Prairie Island Nuclear Generating Plant Units 1 and 2
Dockets 50-282 and 50-306
License Nos. DPR-42 and DPR-60

Response to Requests for Additional Information (RAI) Associated with Adoption of the Alternative Source Term (AST) Methodology (TAC NOS. ME2609 and ME2610)

Nuclear Regulatory Commission (NRC) Request for Additional Information (RAI)

The sequence of events for the limiting scenario analysis is presented in Table 1. Figures 1 through 8 provide the time-dependant values of the following parameters for the limiting MTO scenario:

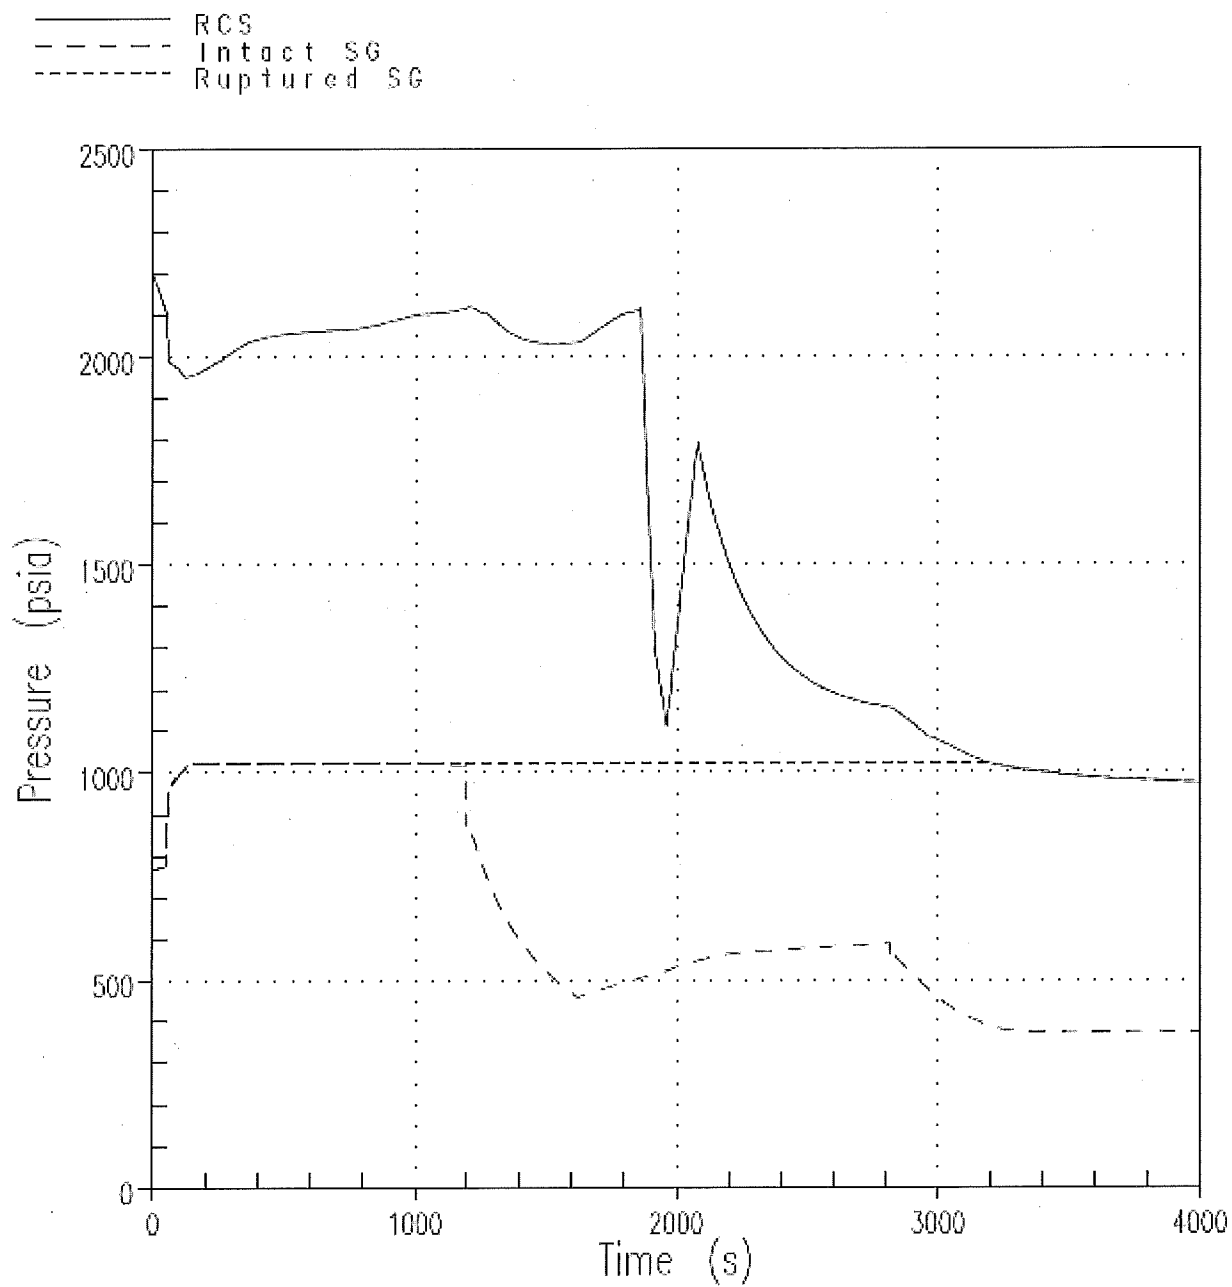
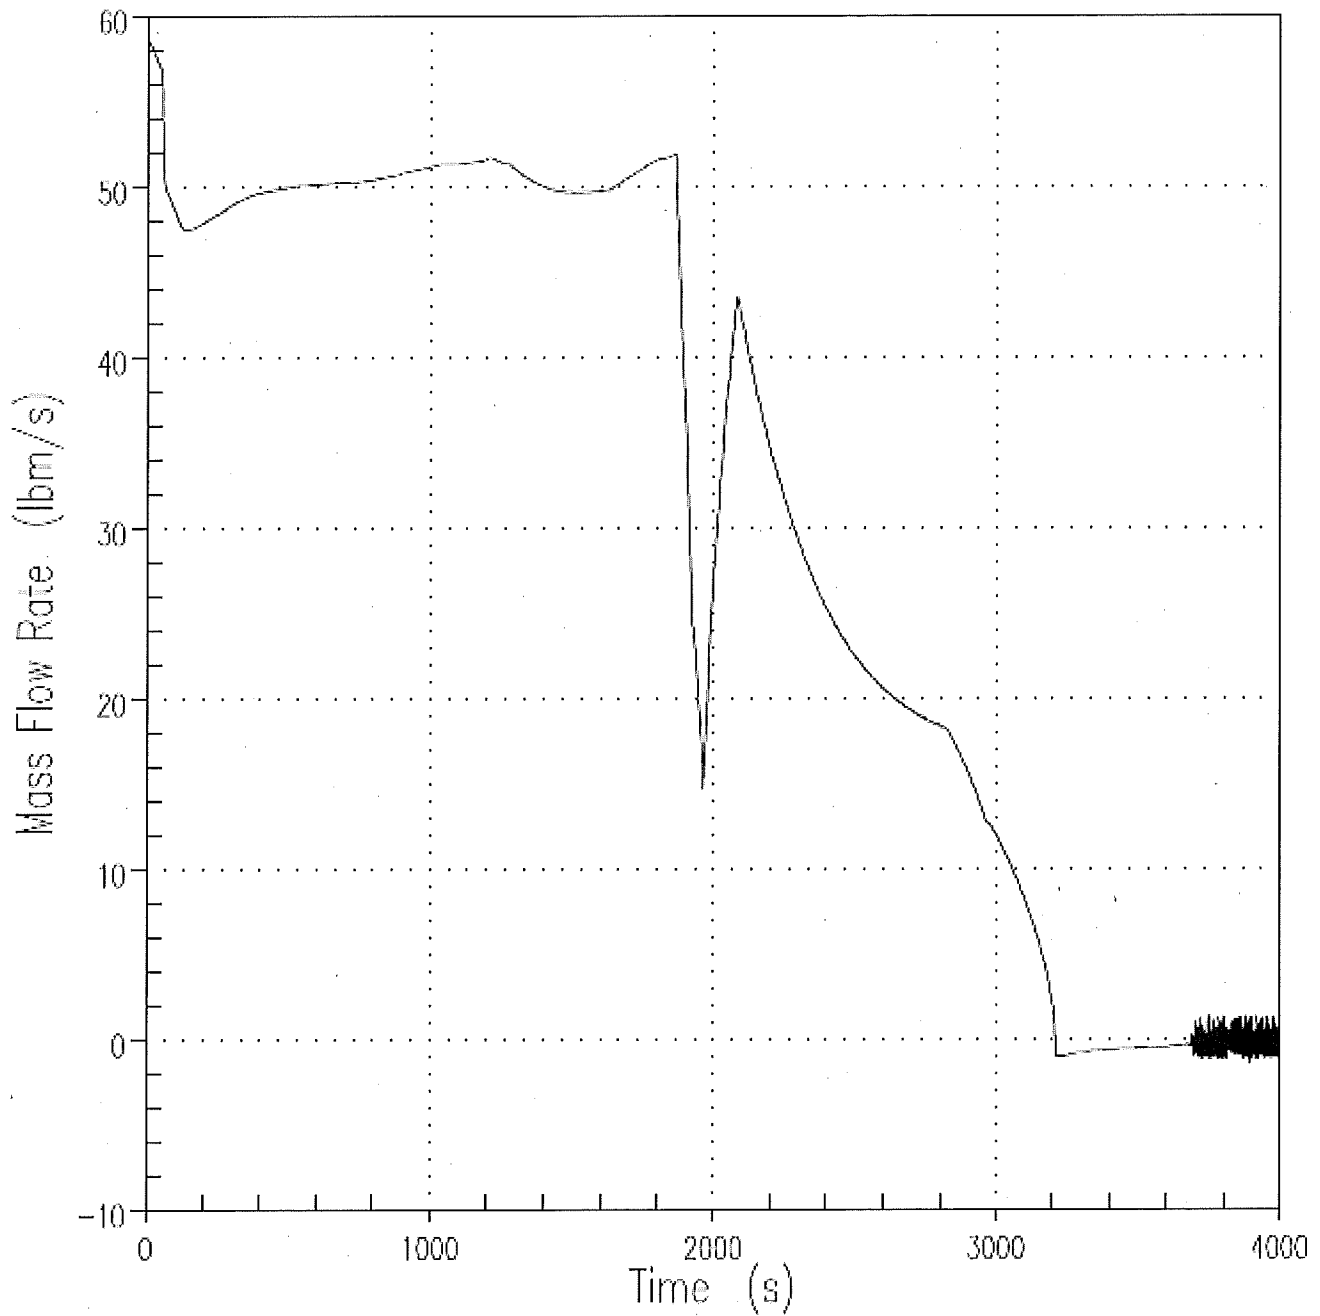
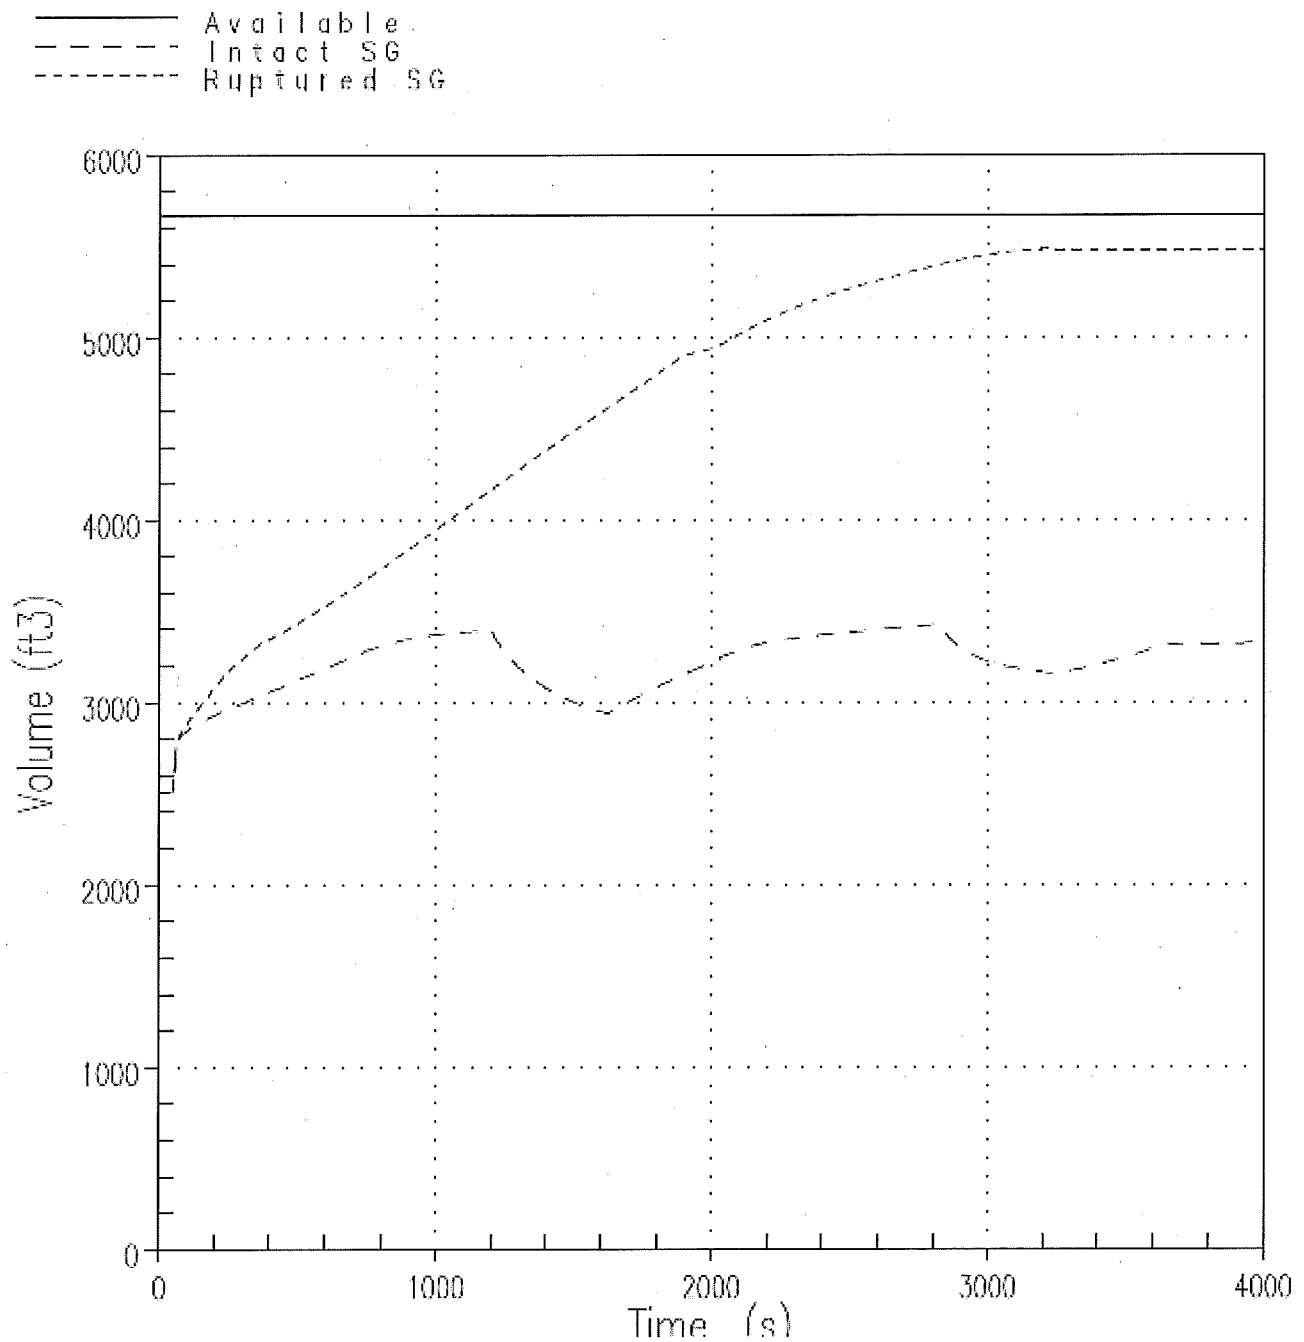
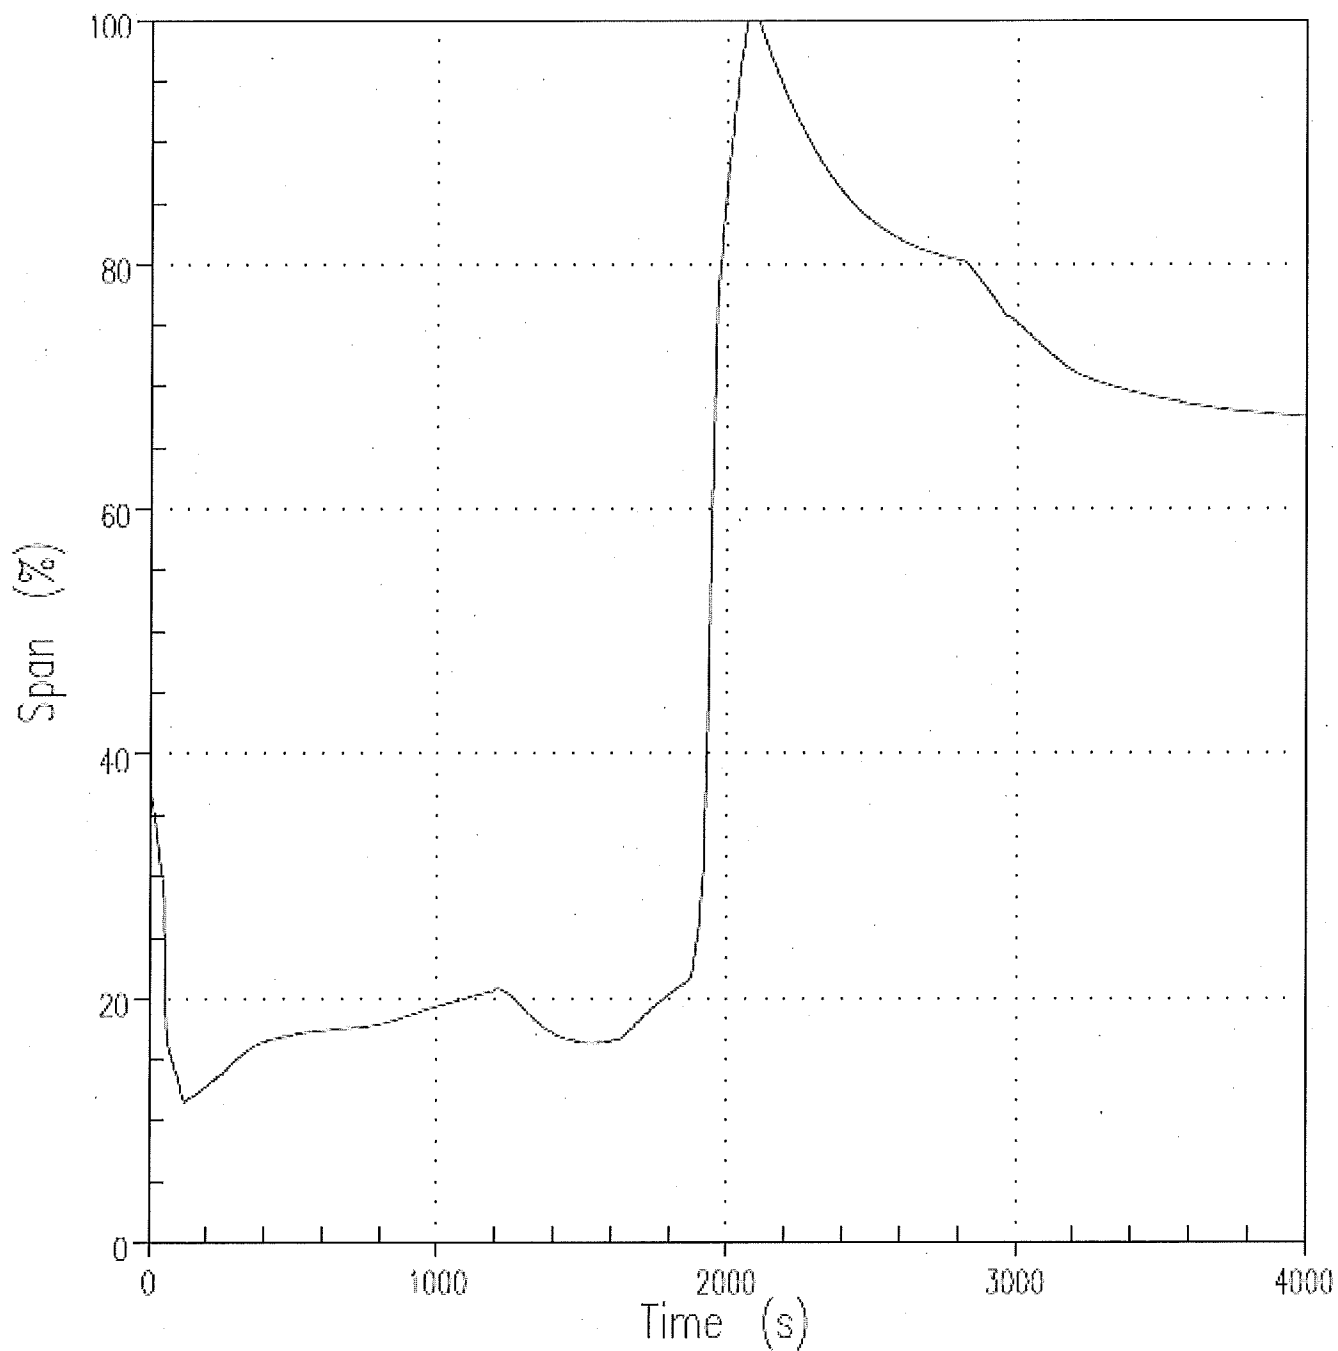
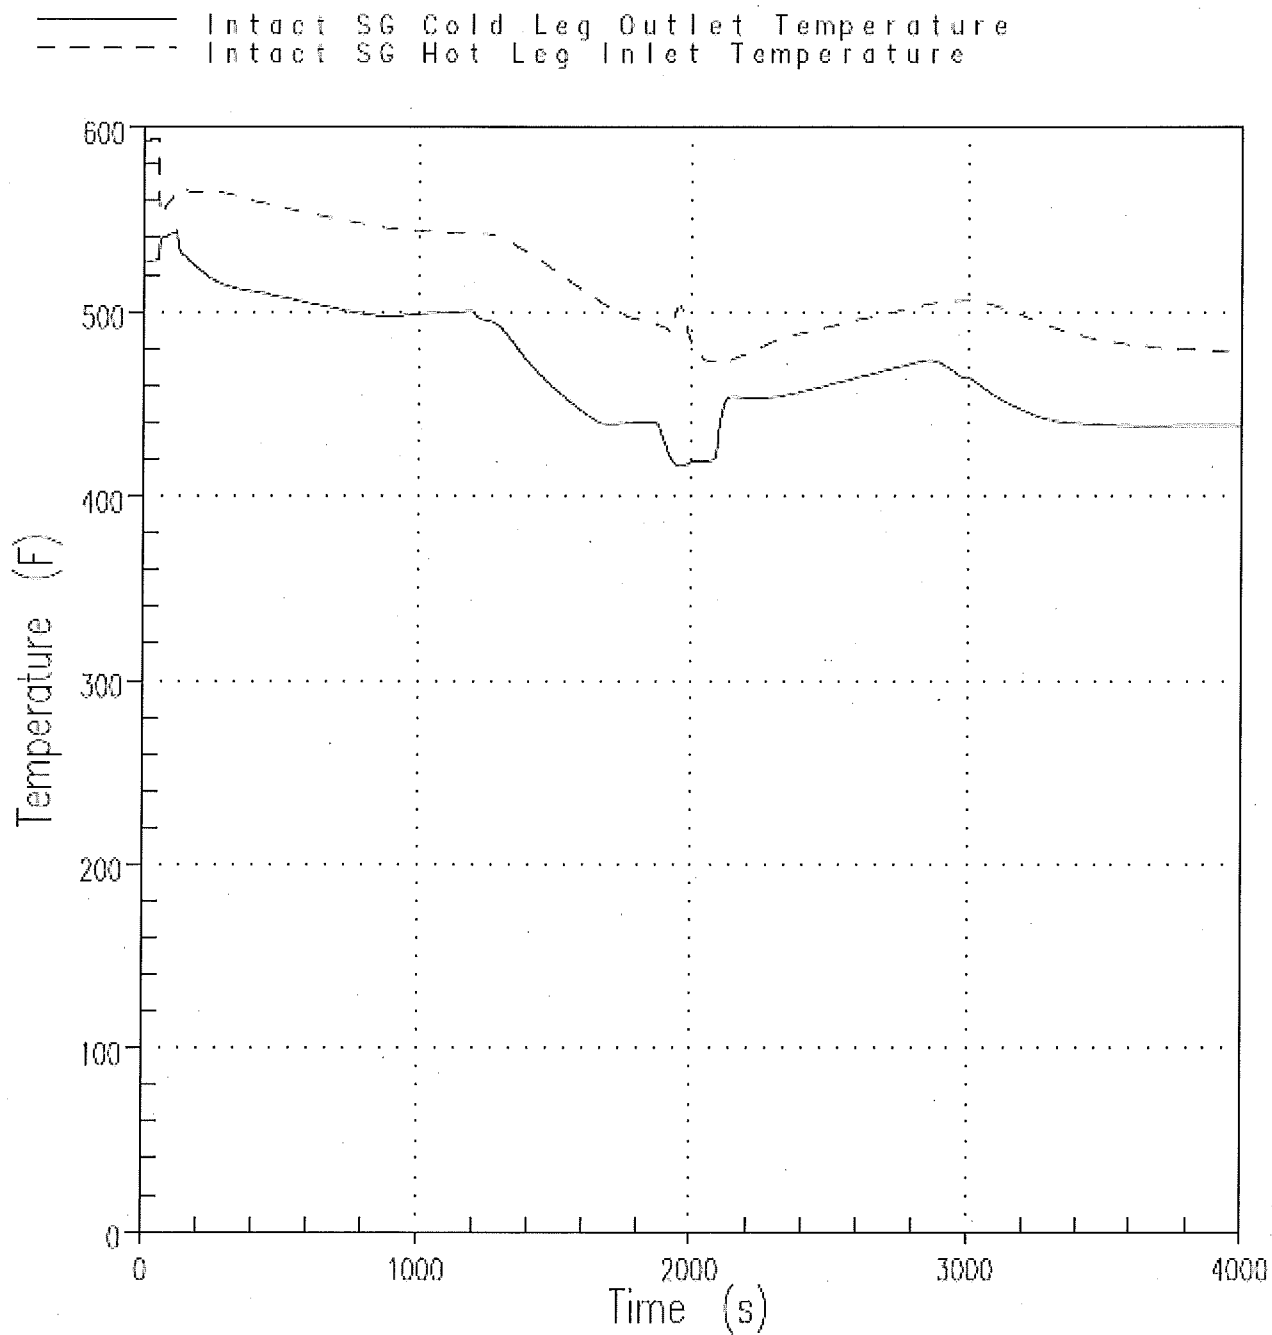
- A.2 *Alternatively, the licensee may perform an SGTR MTO analysis for PINGP at current licensed thermal power conditions. The analysis should align as closely as possible to an NRC-approved methodology described in a Westinghouse topical report, WCAP-10698-P-A. However, since the licensee has stated that a limiting single failure is not in the PINGP licensing basis, this exception to the WCAP-10698-P-A methodology will be acceptable. The requested analytical results should include sequences of the event with specification of operator actions and the associated times credited in the analysis, and the response of key plant parameters versus time.*

NSPM has performed sensitivity analyses to determine the limiting margin-to-overfill (MTO) scenarios at 1683 MWt, which is the current licensed reactor core power level of 1677 MWt, plus calorimetric uncertainties. The analyses followed the methodology in WCAP-10698-P-A, with the exception of the assumption of a single failure.

The results indicate a margin-to-overfill of 186 ft³ in the ruptured steam generator for the limiting scenario. The limiting scenario models 0% steam generator tube plugging (SGTP), low decay heat, maximum safety injection (SI) enthalpy and minimum auxiliary feedwater (AFW) enthalpy. No water is transferred into the steam lines.
